Addendum Three

The Renovations & Restorations of the Westport Community Center

Issued: Monday, December 19, 2016

1 Typical Work Counter Detail

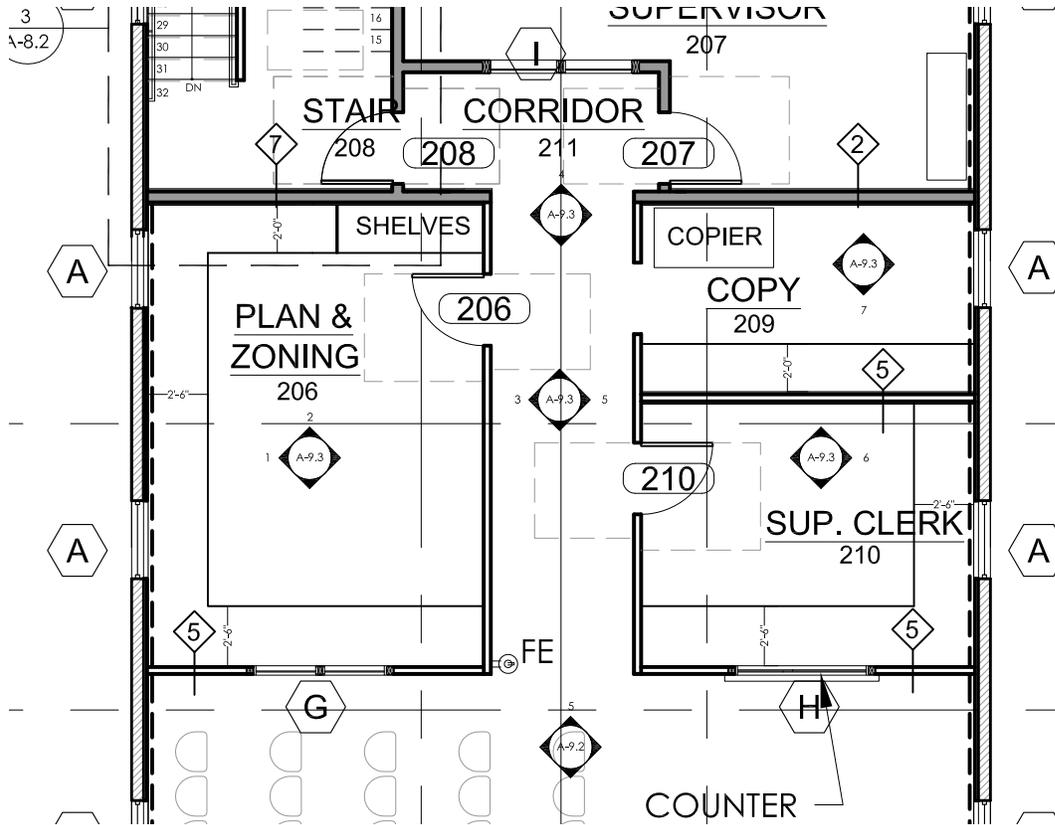
23. Are the countertops in 206, 209,210 plastic laminate? What is the extent of the tops and how deep are they?

Counters are Plastic Laminate with wood nosing – see attached detail and sketch.

SK 4 - Westport Community Center
December 19, 2016

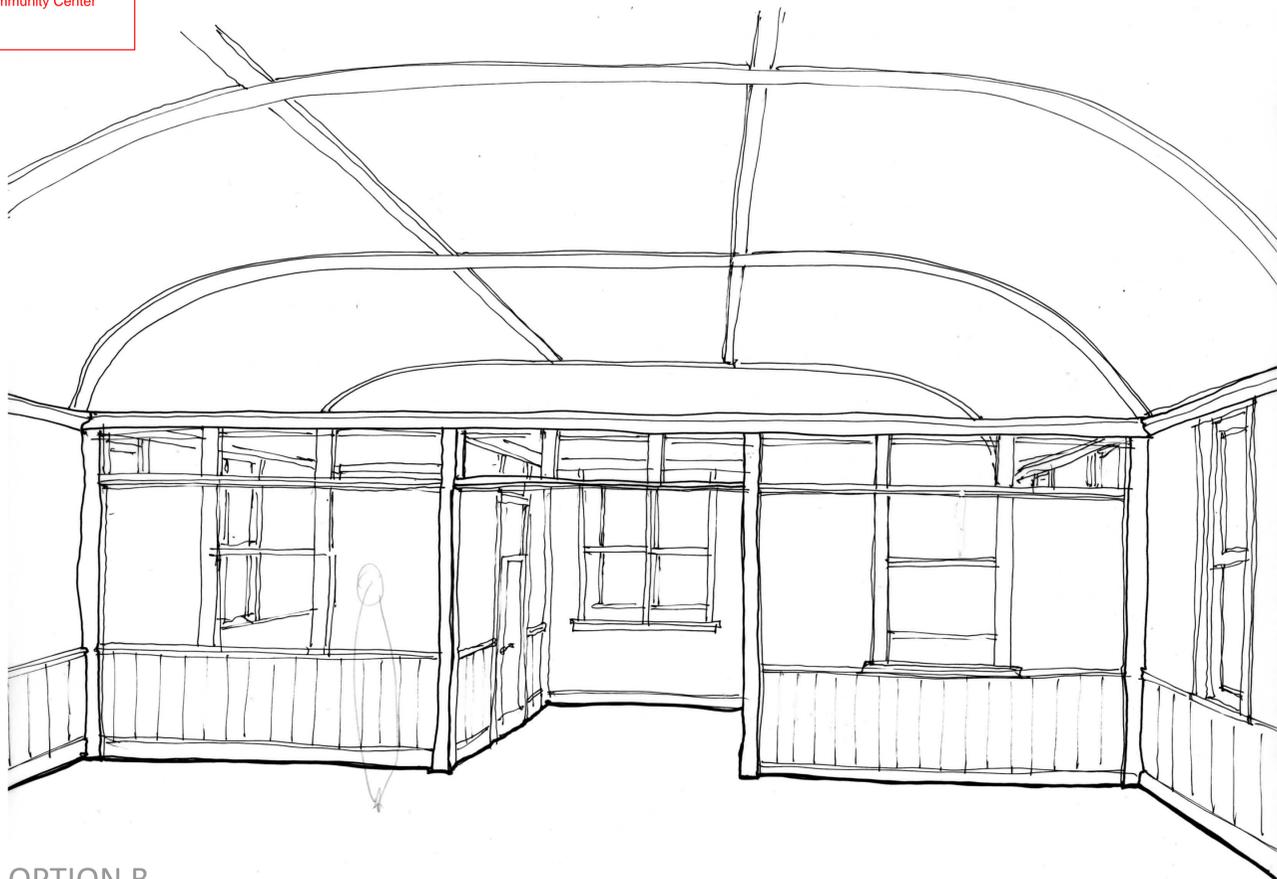
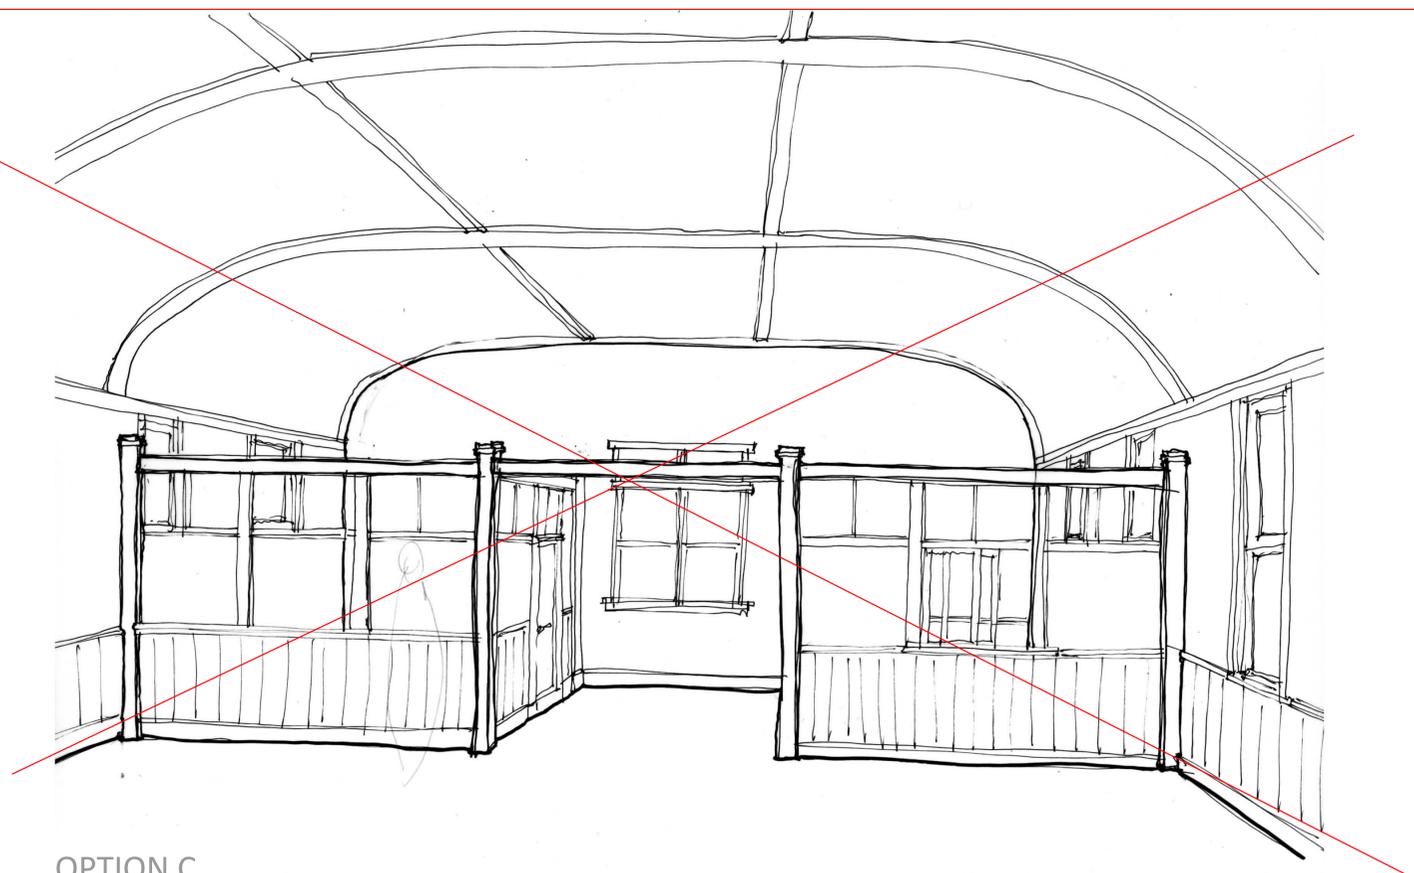
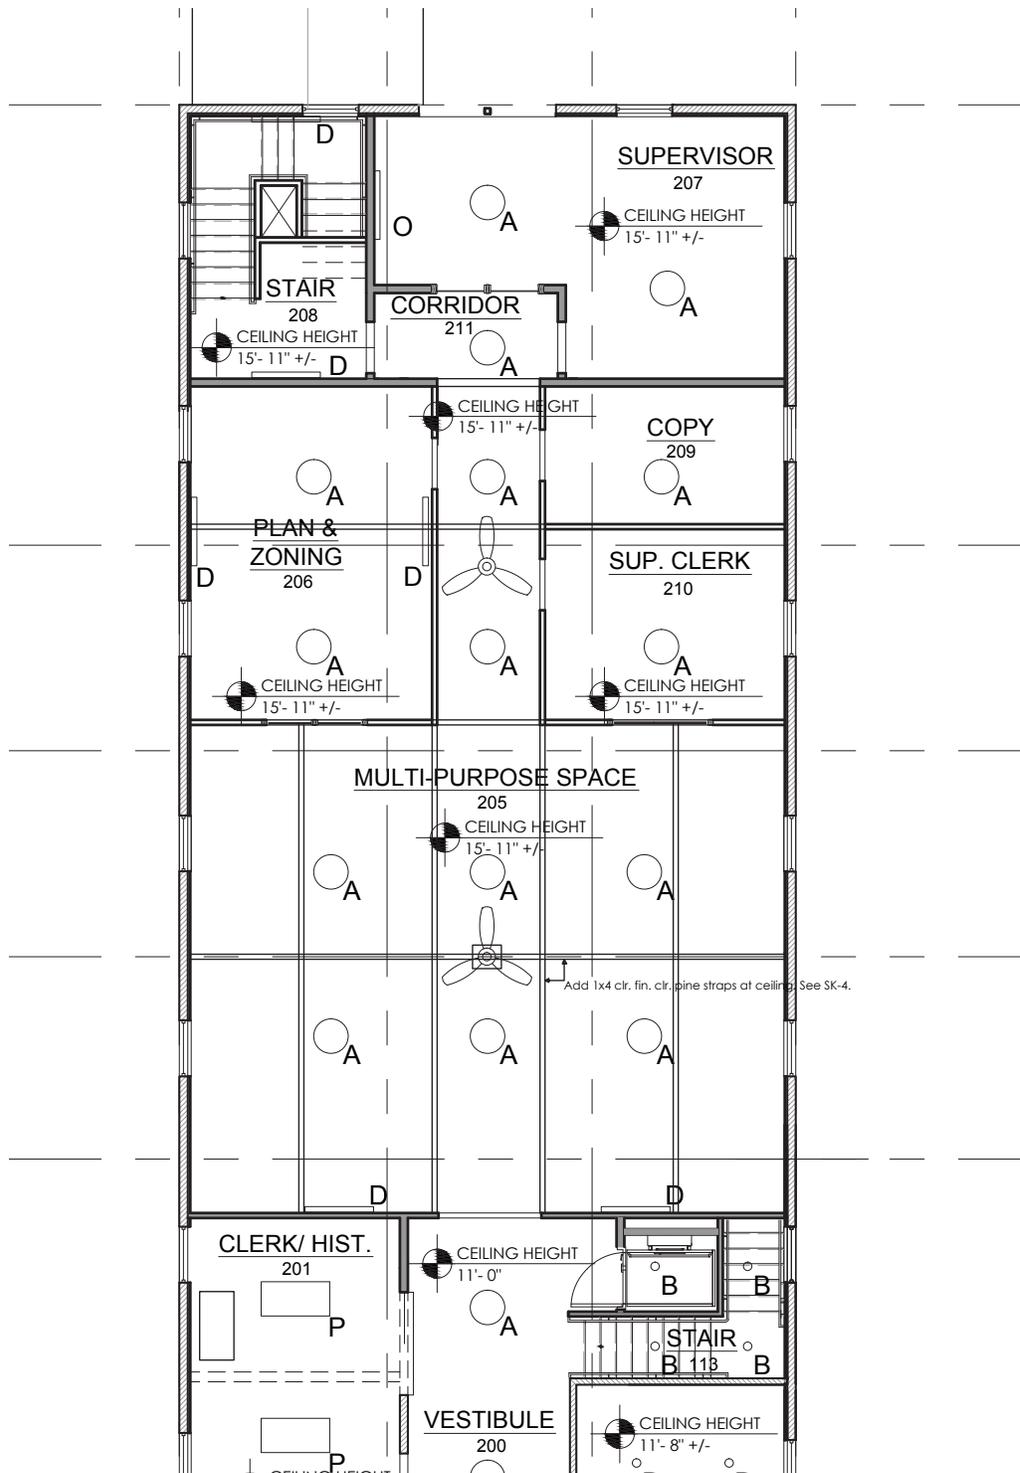
22. I am unable to find any drawing depicting woodwork on the vaulted ceiling on the main floor, it is scheduled and specified.

The only wood on the ceiling of the meeting room shall be the straps as shown on the attached sketches SK 4 & 5. Otherwise the ceiling is gypsum wallboard.

M1.11

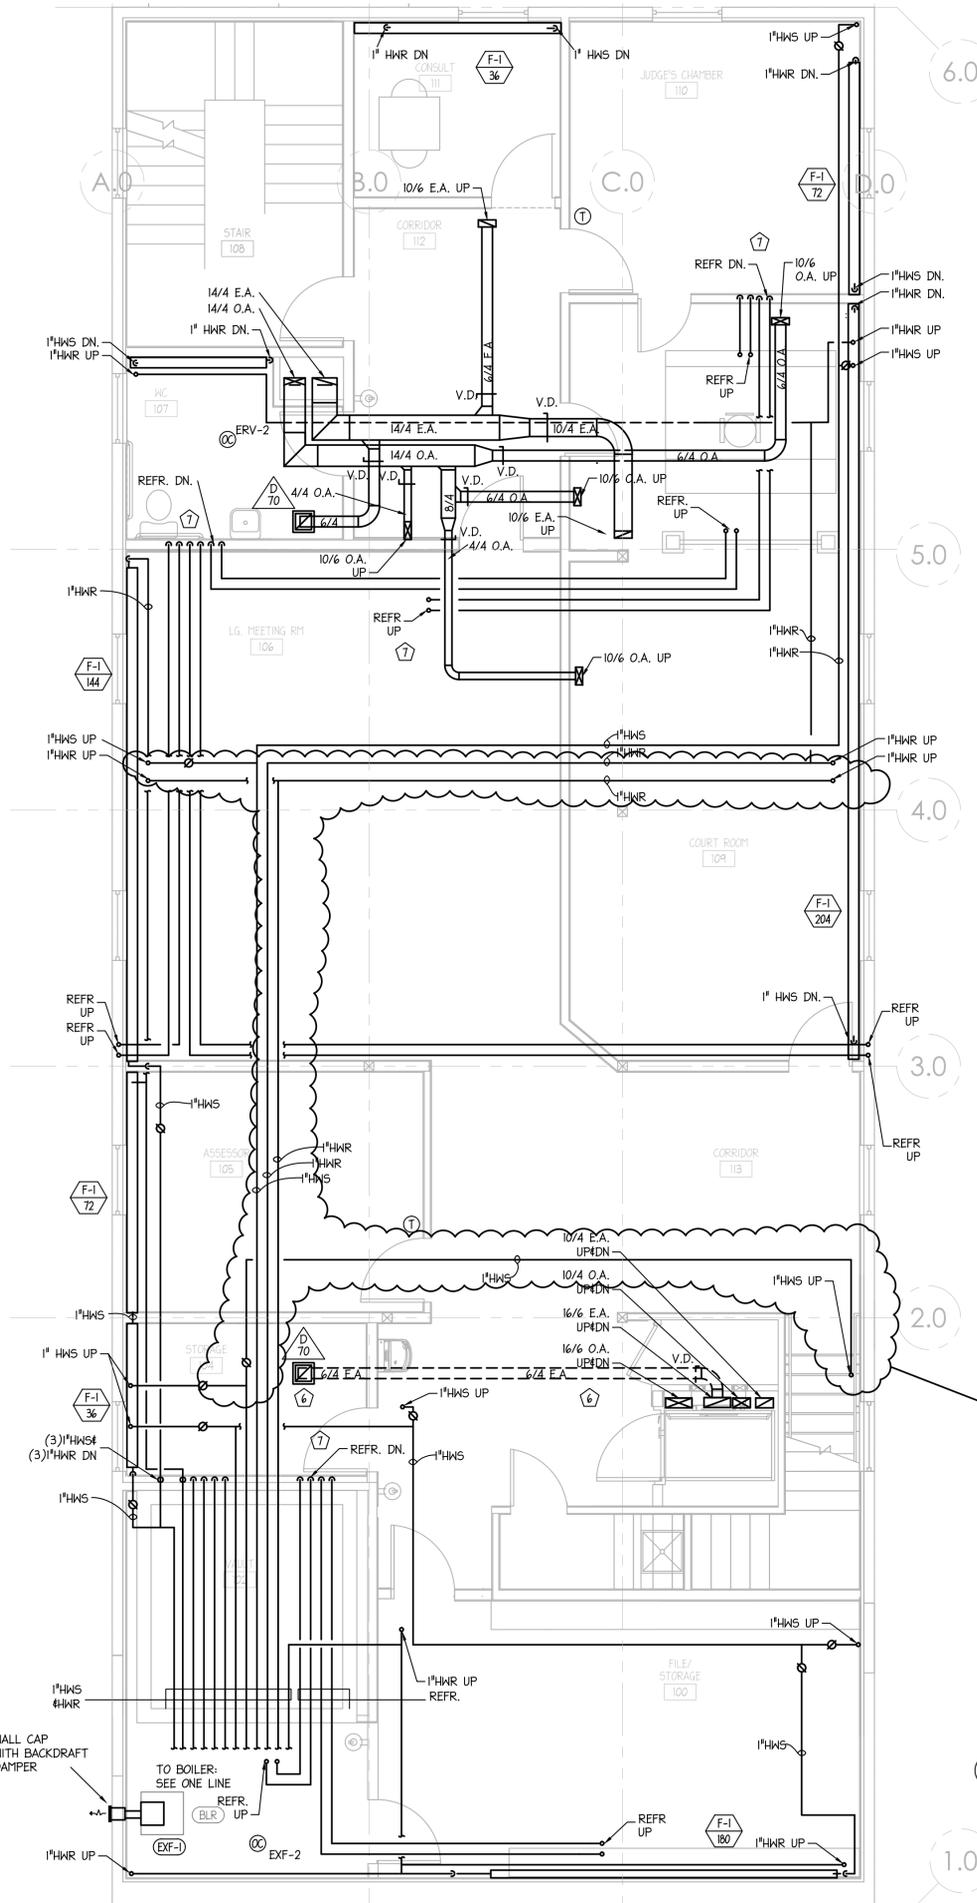
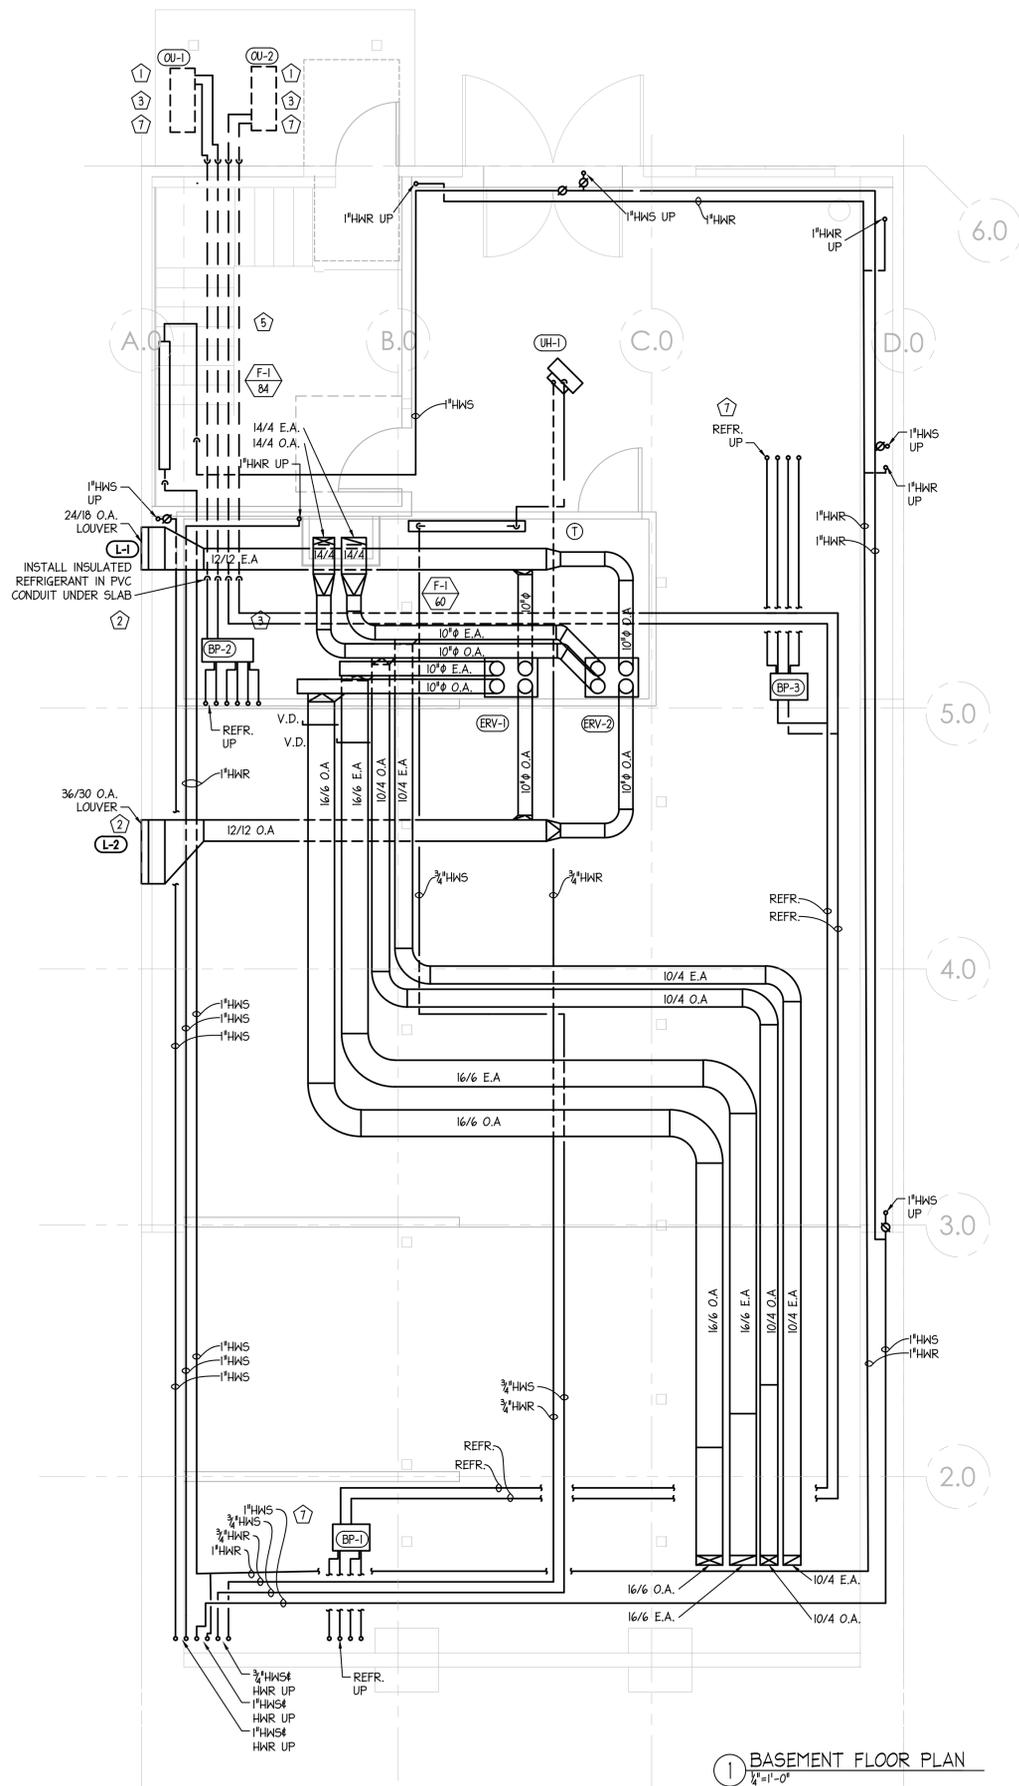
1. What is the condensate pipe material and size?
All condensate piping shown on P1.11 & P1.21 to be 3/4" insulated copper or PVC.
2. What is the required duct connection for duct less than 144 sq in? (note 6, M5.01)
3. Which contract is responsible for the condensing units 4" concrete housekeeping pad?
4. Which contact is responsible for the louver wall penetrations?

For Questions 2 – 4 above, please see attached drawings M1.11 and M1.21 for additional notes and clarifications.
